18 November 2021

Mark Foster, SNF Environmental Coordinator Attention: Shoshone NF Travel Management Planning Project Shoshone National Forest 808 Meadow Lane Avenue Cody, Wyoming 82414

SUBJECT: Comments on Shoshone National Forest Travel Management Plan Environmental Assessment (EA)

FST 608, Old Tie Hack logging road, looking east, August 2021, Photo by Robert Hoskins

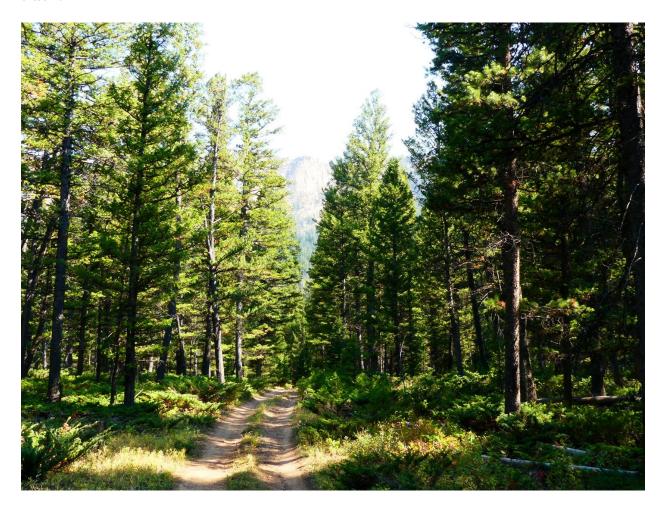
The below photo depicts FST 608 down near the Creek. Historically, 608 is an extension of FSR 529 from the north over Warm Spring Creek, a logging track originally built in 1925 to allow tie hacks to log an area south of the Creek that is relatively flat. It is marked on the 1956 Warm Spring Mountain quadrangle (USGS) as an unnamed trail. Note the lushness of the forest either side of the track.

Warm Spring Creek crossing, looking north, August 2021, Photo by Robert Hoskins

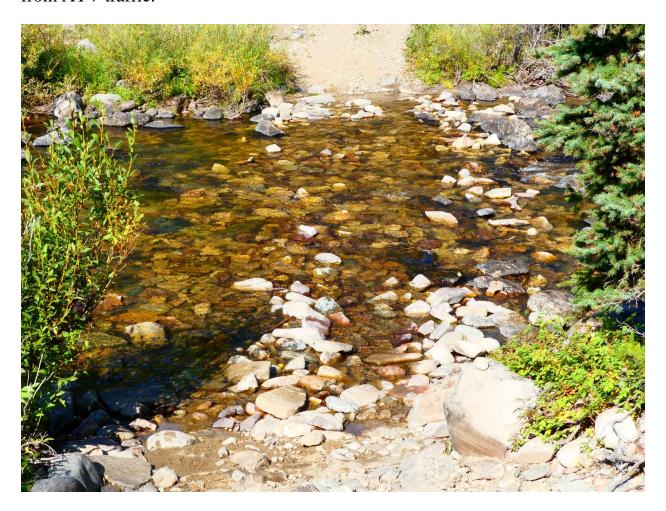
The below photo depicts the crossing of Warm Spring Creek. Clearly, someone has placed flagstones and other rocks over the crossing to protect the streambed from ATV traffic.
